| - | 02-16-93 | RELEASED FOR PRODUCTION | R.T. |

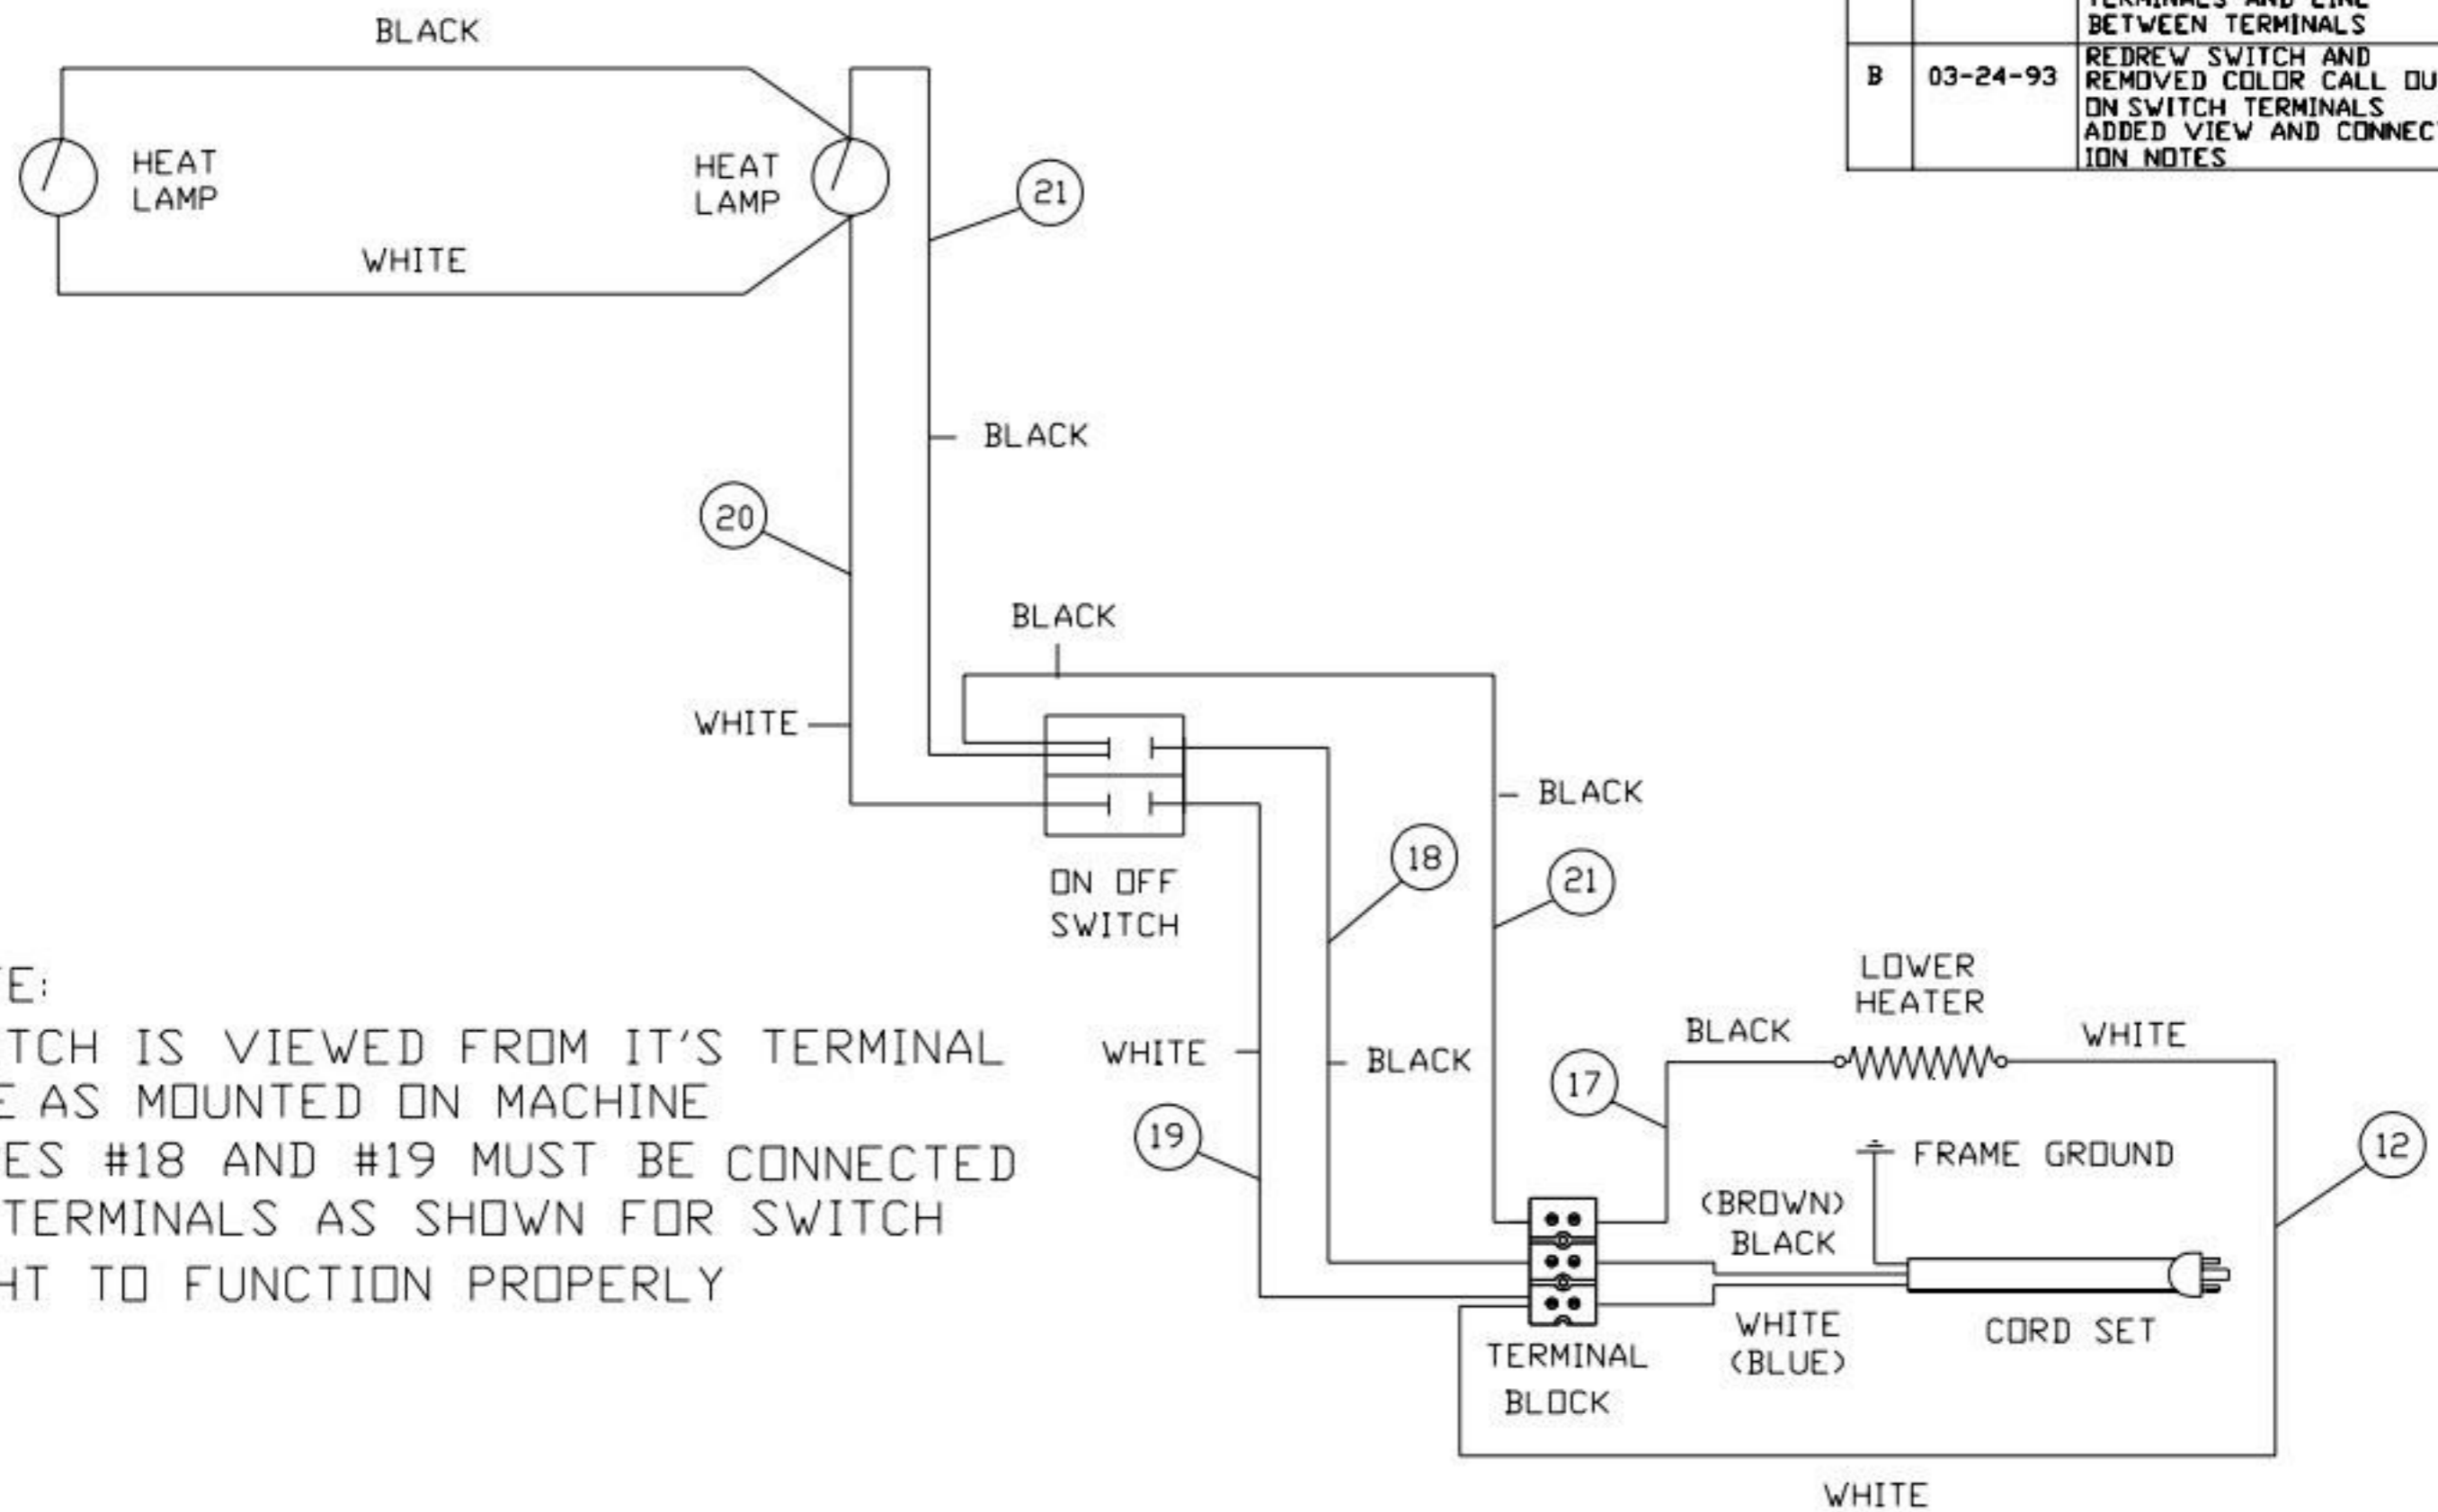
| A | 03-22-93 | ADDED COLOR TO SWITCH TERMINALS AND LINE BETWEEN TERMINALS | R.T. |
| B | 03-24-93 | REDREW SWITCH AND REMOVED COLOR CALL OUT ON SWITCH TERMINALS ADDED VIEW AND CONNECTION NOTES | R.T. |

NOTE:
 SWITCH IS VIEWED FROM IT'S TERMINAL
 SIDE AS MOUNTED ON MACHINE
 WIRES #18 AND #19 MUST BE CONNECTED
 TO TERMINALS AS SHOWN FOR SWITCH
 LIGHT TO FUNCTION PROPERLY
